EMERSON PARK JSP17-10 with Rezoning 18.717

EMERSON PARK JSP 17-10 AND ZONING MAP AMENDMENT 18.717

Consideration at the request of Pulte Homes of Michigan, LLC for Planning Commission's Recommendation to City Council for a Planned Rezoning Overlay Concept Plan associated with a Zoning Map amendment, from OS-1 (Office Service) to RM-2 (High Density Multi-Family Residential). The subject property is approximately 24-acre and is located on the west side of Novi Road and north side of Ten Mile Road in Section 22. The applicant is proposing a development of 120-unit multi-family attached condominiums with frontage and access to Novi Road

PLANNING REVIEW

sheet title:
**OVERALL PLANTING
PLAN VIEW**

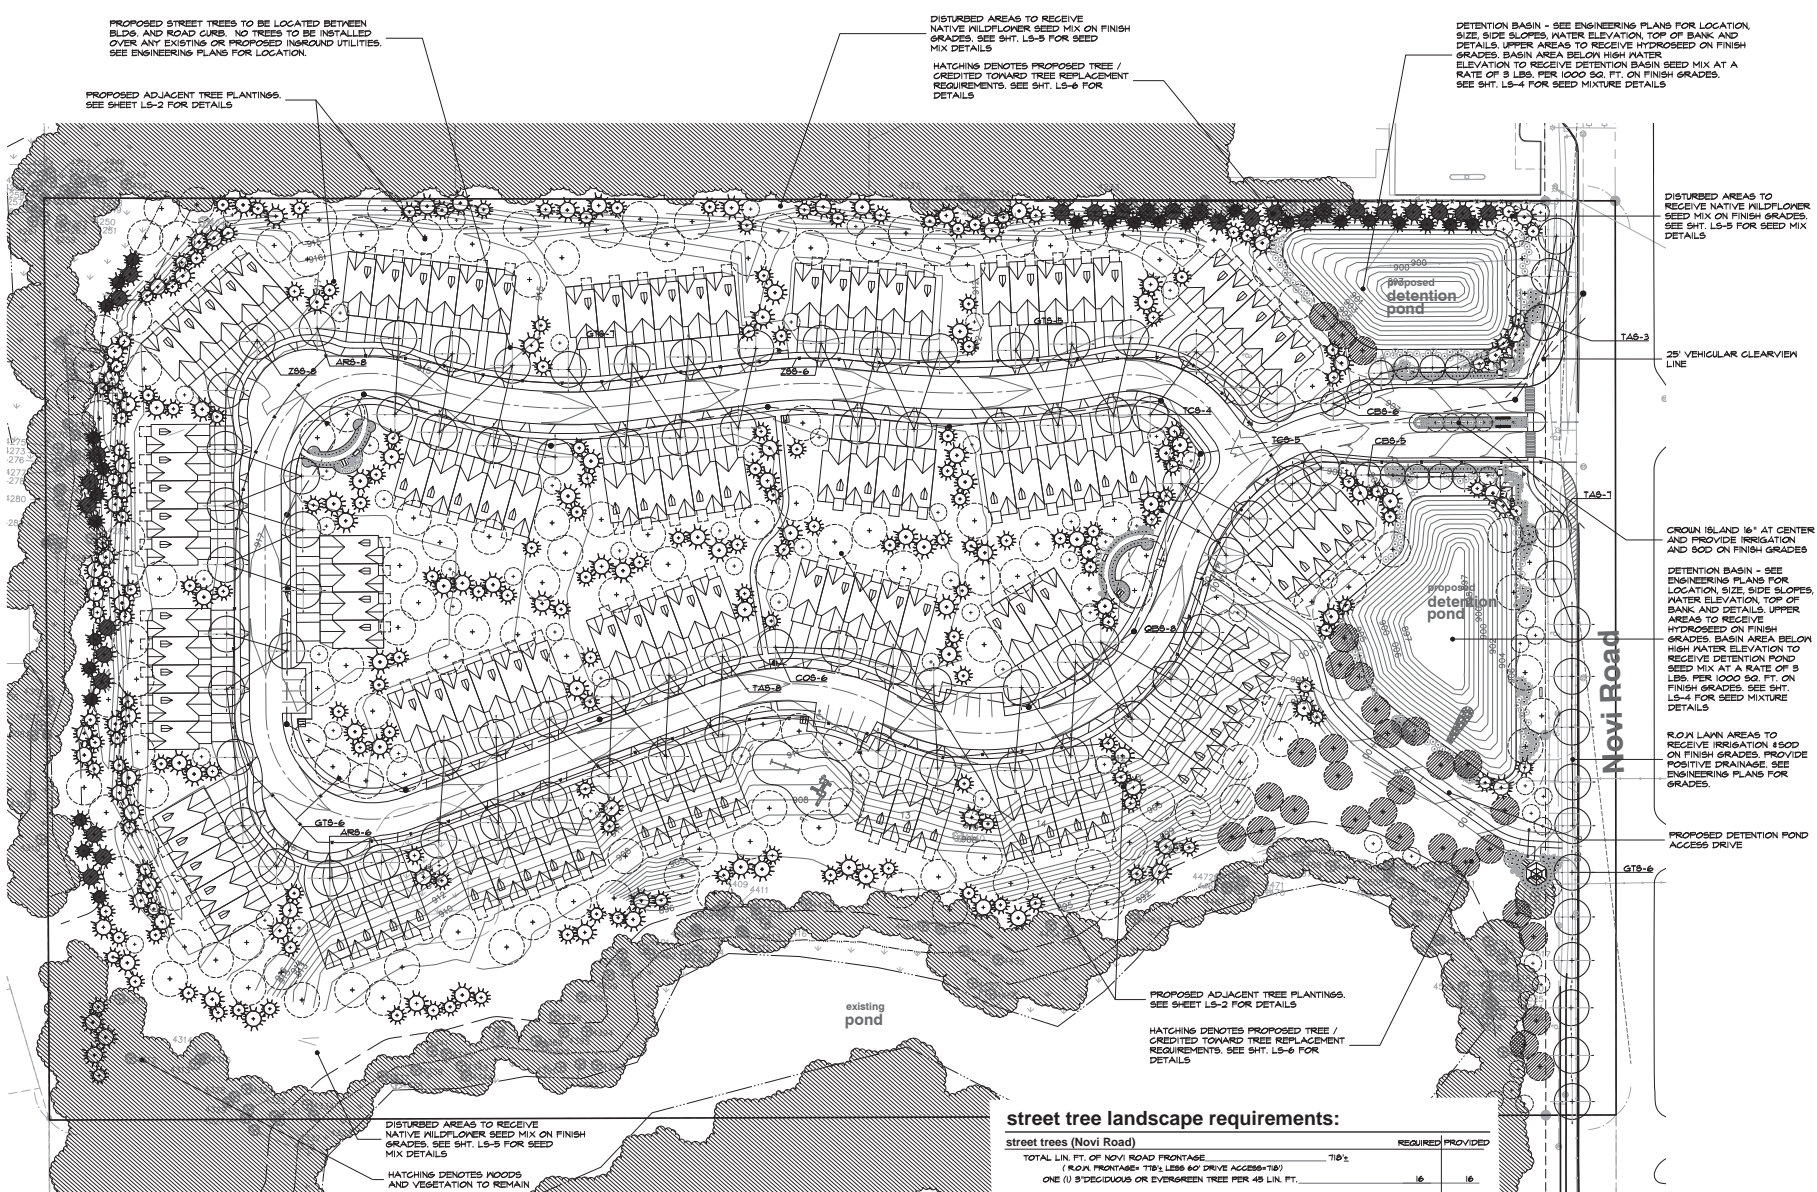
4. There is a contradiction between the two figures used as a basis for the street trees calculations. 3349 lf is shown as the basis, but the calculations show the number to be 2821 lf. The latter figure was used for the tree requirement. **Please use the correct number as the basis and remove the incorrect figure from the calculations. If the correct figure is 2,080 lf, then more than the required number of street trees is provided.**

1. The detail is provided on Sheet 4.
2. **When proposed transformers/utilities/fire hydrants are available, add them to the landscape plan and adjust plant spacing accordingly.**

Figure 1. City of Novi Regulated Wetland & Woodland Map (approximate project area is highlighted in red). Regulated Woodland areas are shown in green and regulated Wetland areas are shown in blue).

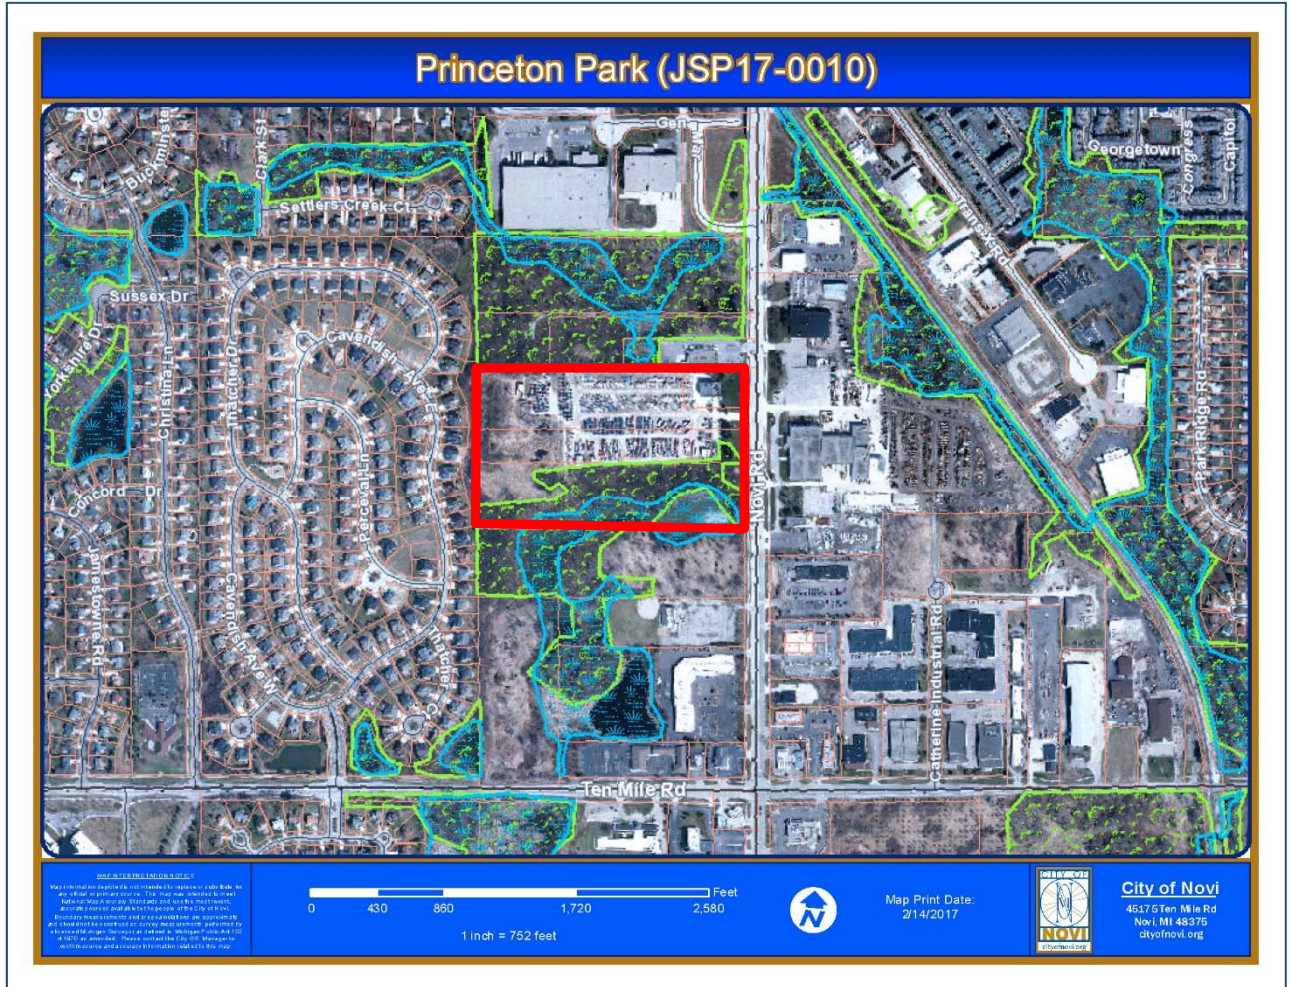
Based on our review of the Plan, Novi aerial photos, Novi GIS, the City of Novi Official Wetlands and Woodlands Maps (see Figure 1, attached) it appears as if this proposed project site contains City-regulated wetlands and woodlands. The City's wetland and woodland map shows that the overall property contains wetlands to the south. However, a review of aerial photos of the site and the proposed site plan, the site contains three (3) areas of wetland (Wetlands #1, #2, and #3), along both the southern and western portion of the site.

As noted, three (3) areas of wetland exist on this parcel (Wetland #1, #2, and #3). The proposed site development appears to be partly designed around the existing on-site wetland and 25-foot wetland setback areas. The *Layout Plan* (Sheet 05) indicates that the proposed development will impact Wetland #3 and the storm water outlet is currently planned to be directed to the 25-foot setback of Wetland #1, in the southeast portion of the site. The following table summarizes the existing wetlands and the proposed wetland impacts as shown on the Plan:

Figure 1. City of Novi Regulated Wetland & Woodland Map (approximate project area is highlighted in red). Regulated Woodland areas are shown in green and regulated Wetland areas are shown in blue).

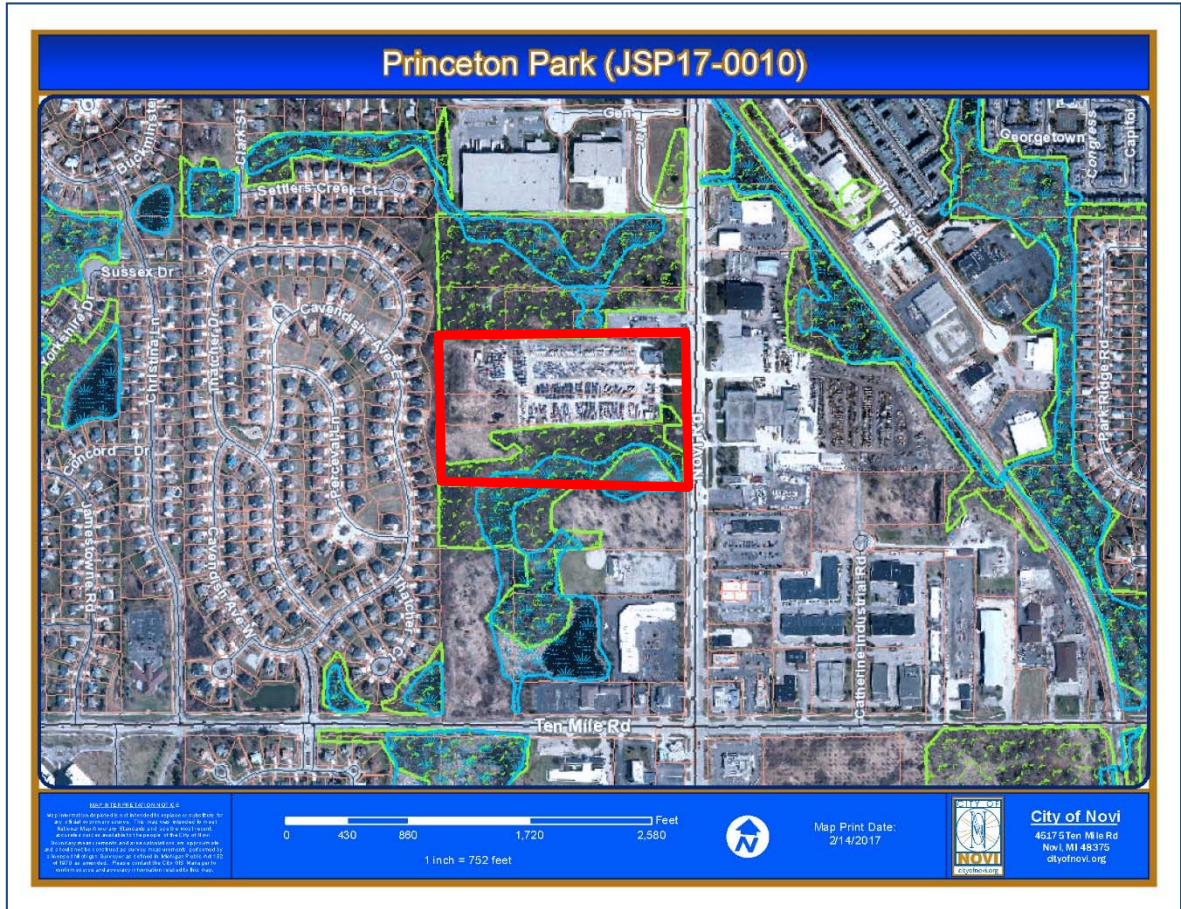
ECT completed an on-site woodland evaluation on Tuesday, February 21, 2017. As noted above, the site does contain area designated as City of Novi Regulated Woodland. A significant portion of the proposed limits of disturbance for the project is located outside of the areas mapped as City Regulated woodland (see Figure 1). The

majority of the Regulated Woodland area is located on the southern portion of the project site (see Figure 1). Tree survey information has been provided on the *Tree List* plan (Sheet 03). This sheet includes a tree list that indicates the proposed woodland impacts and required Woodland Replacement tree credits for these removals. The Plan indicates that a total of 328 trees have been surveyed for the project. Of the trees surveyed, 262 trees are located within the area designated as Regulated Woodland (80% of the surveyed trees are located within the regulated woodland area). Fifty percent (50%) of the surveyed trees are comprised of the following tree species:
